# METROPOLITAN GOVERNMENT OF NASHVILLE AND DAVIDSON COUNTY

## STAFF RECOMMENDATION 1504 Elmwood Avenue May 16, 2012

**Application:** Demolition, Infill, and New construction—accessory structure

**Description of Project:** Applicant proposes to demolish a non-contributing building and construct a one-and-a-half story dwelling with a detached rear accessory building.

GARAGE  
GARAGE. FLR. (0'-0")

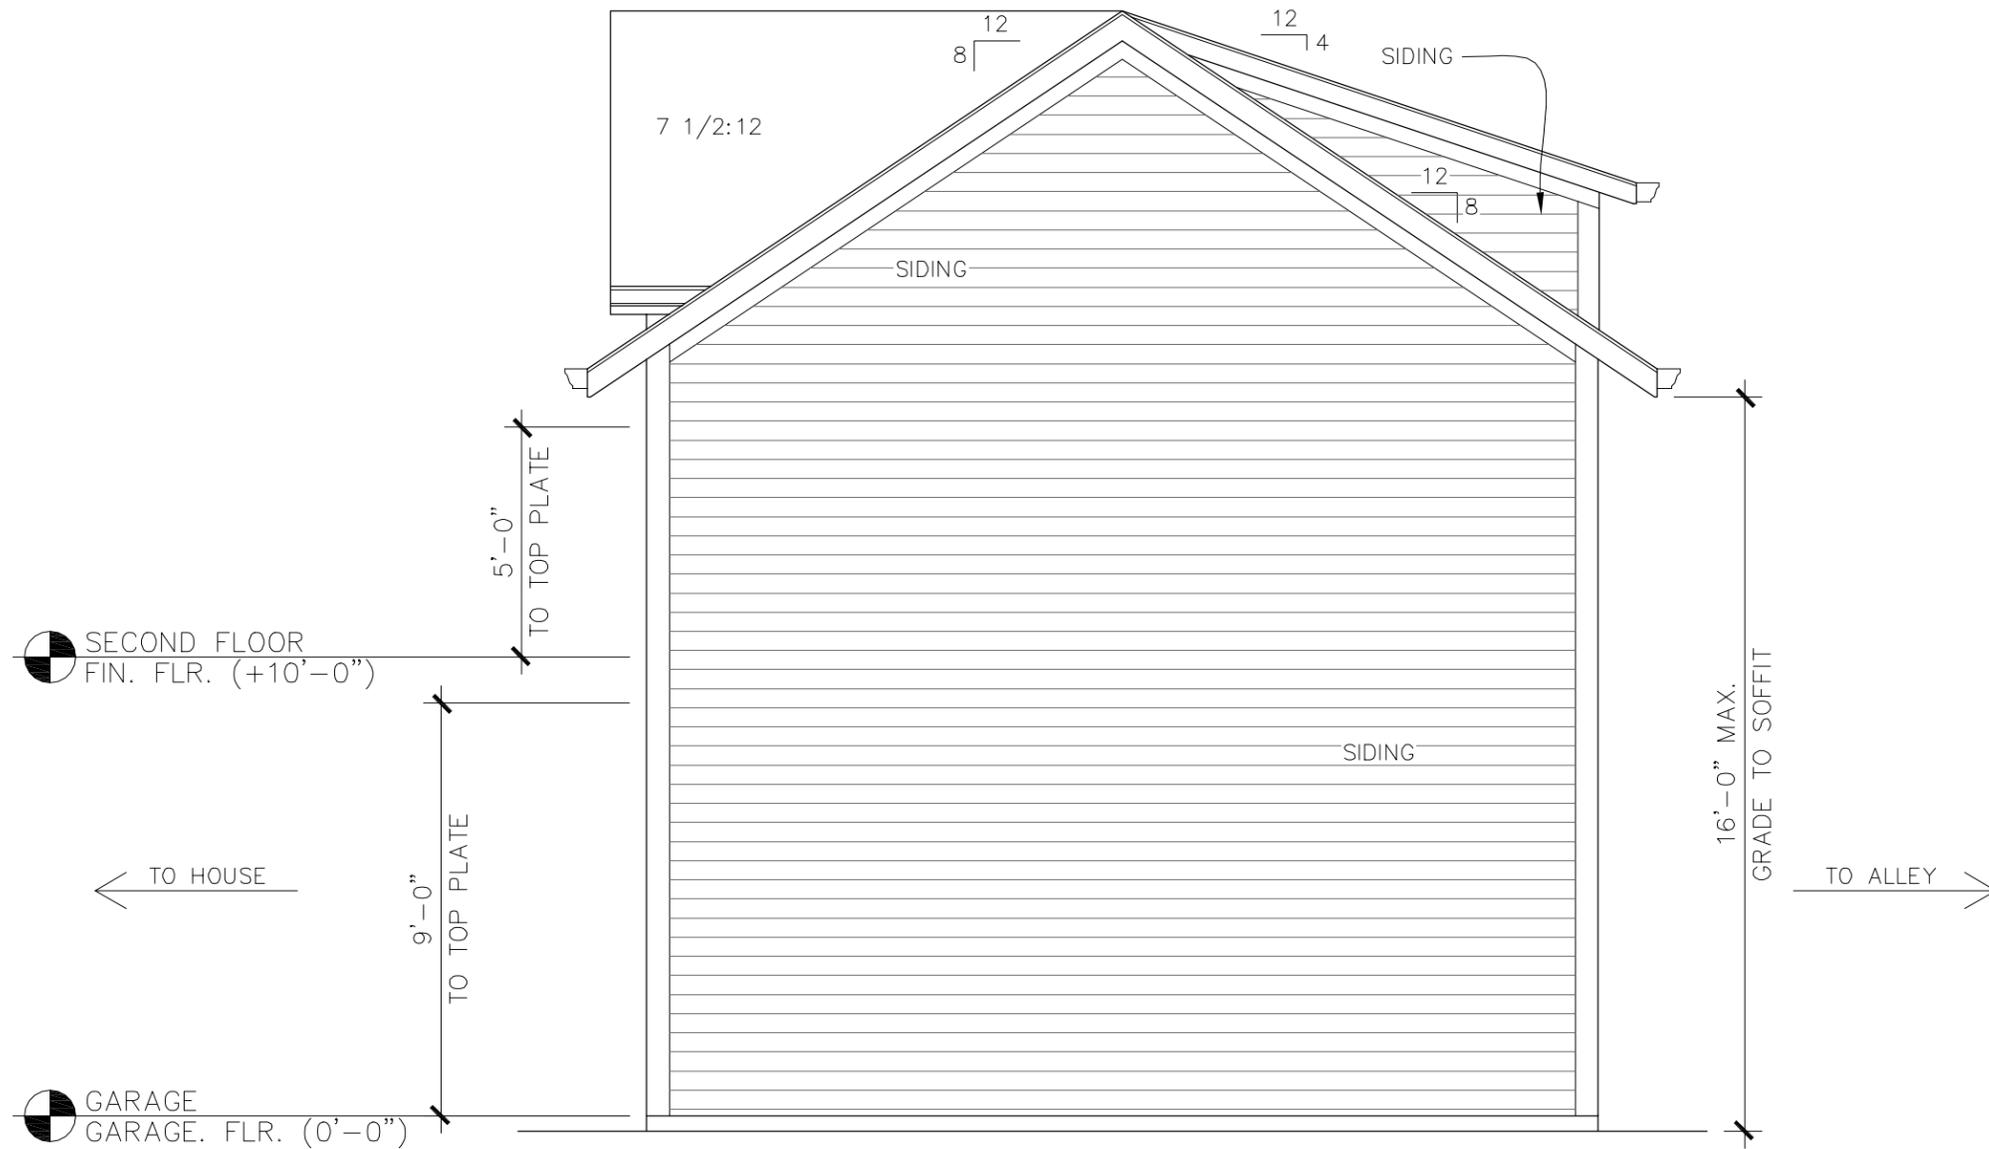
The accessory structure is proposed to have an eave height of sixteen feet (16') and a ridge height of twenty-four feet, six inches (24'6"). Staff finds that the height of the accessory structure is not subordinate to the proposed infill, which will have an eave

height of twelve feet, nine inches (12'9") and a ridge height of twenty-six feet, nine inches (26'9"). Staff asks that both the ridge height and the eave height of the accessory structure be lowered by a minimum of two feet (2'), which, in conjunction with the slope of the site, will help to ensure it is subordinate to the primary structure. In addition, staff asks that a trim board be added to the garage at the floor level to help minimize the perceived height of the structure.

With the reduction of the eave and ridge height by a minimum of two feet (2'), the addition of the trim board, and the staff's final approval of the windows and doors, staff finds that the proposed accessory structure meets Section II.B.1.i. of the *Belmont-Hillsboro Neighborhood Conservation Zoning Overlay Handbook and Design Guidelines*.
